RTCA Special Committee 209 / EUROCAE WG49

ATCRBS / Mode S Transponder MOPS Maintenance

**Additional information in the UM field
to indicate which BDS content is provided in MB**

(In Response to Action 12-03)

2.2.19.1.9 UM Protocol (Figure 2-18)

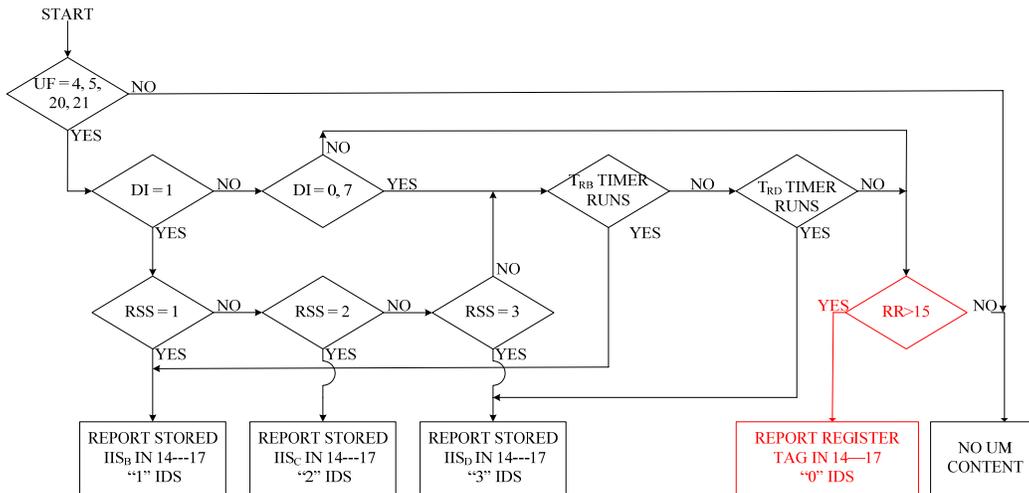
- a. Field description is in §.
- b. If DI=1, multisite information may be requested as specified in §.
- c. If no request appears, directed Comm-B/D information may appear in UM as specified in § and §.
- d. If no request appears, and if there is no multisite reservation, and no directed Comm-B/D and there is a Comm-B message accompanying the UM field (i.e., RR>15 resulting in a DF20/21 message) a Register Tag corresponding to the register downlinked in the MB field is transmitted using the UM field as specified in 2.2.19.2.1.2.

DO-181 Figure 2-19 and ED-73 Figure 3-17 must be modified as follows:

Note 2: REGISTER TAG is defined in table B-2-1.
